SB Number:	SB 2BG-009	Creation Date: 03/03/2005
Subject:	'LEVER LOCK CONTAINER' damaged (toner container)	
Model:	KM-C2630 / C2630D

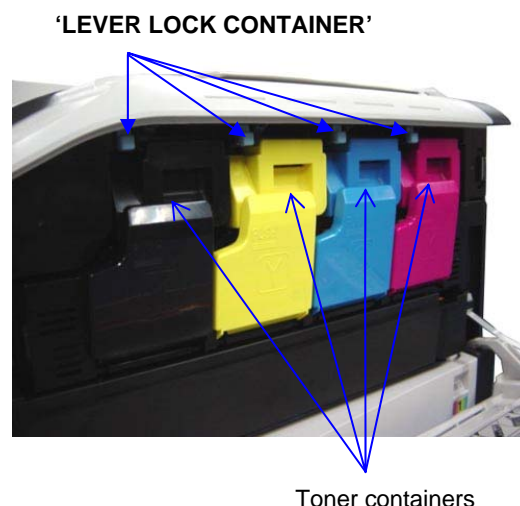
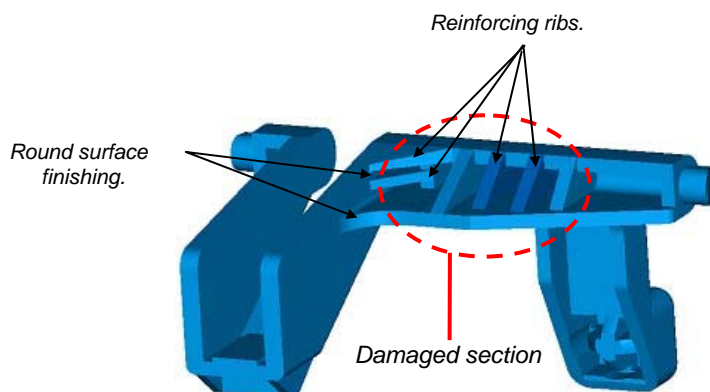
If the toner container is pulled out in the condition that the '**LEVER LOCK CONTAINER**' is not released first, the '**LEVER LOCK CONTAINER**' might become damaged.

To prevent the '**LEVER LOCK CONTAINER**' from being damaged, some reinforcing ribs and a round surface finishing have been added to the '**LEVER LOCK CONTAINER**' for ensuring its strength.

1. Open toner container cover.
2. Push the bottom bar on '**LEVER LOCK CONTAINER**' until the bar makes a click sound. Only after releasing the locked condition, lift up the toner container slightly and pull out the toner container.

If the phenomenon should arise, please replace old part no. 1 with new part no. 1. In addition, please instruct the user to pull out the toner container only after releasing the '**LEVER LOCK CONTAINER**'.
